# ERRATA FOR REPORT 238

## GROUND-WATER AVAILABILITY IN TEXAS

(Published by the Texas Department of Water Resources, September 1979)

Pages 15 and 51,

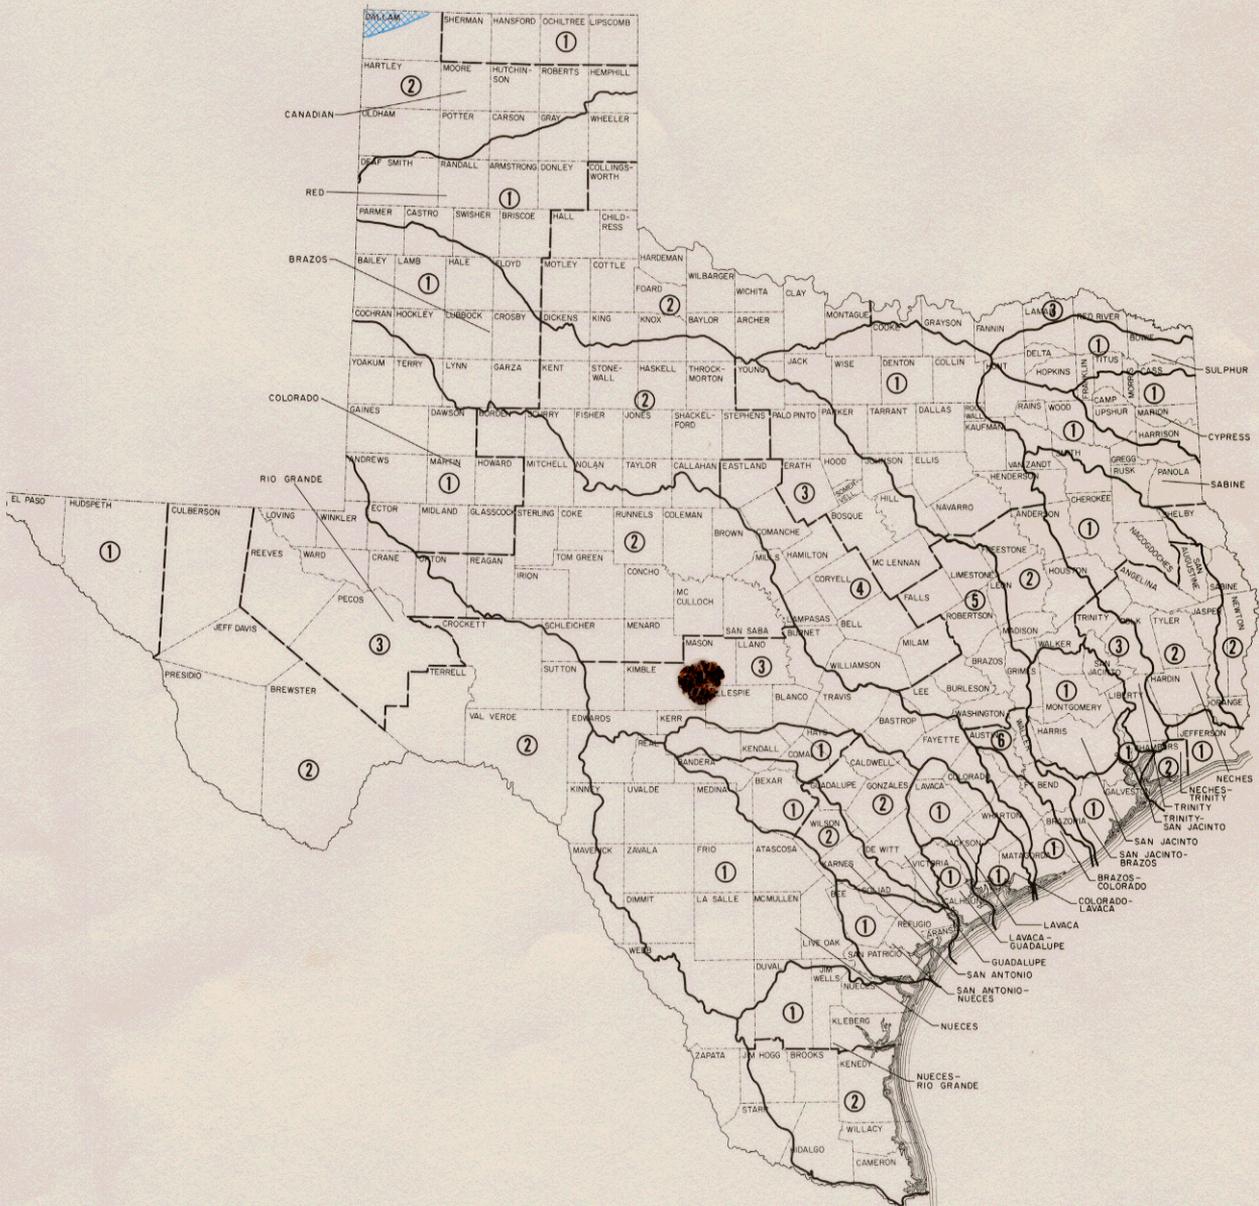
Figure 6 and Figure 12 should reflect the basin boundaries, zone boundaries and basin names shown on the map below. Note: The map below reflects a correction on the boundary between zones 1 and 2 of the Trinity River Basin.
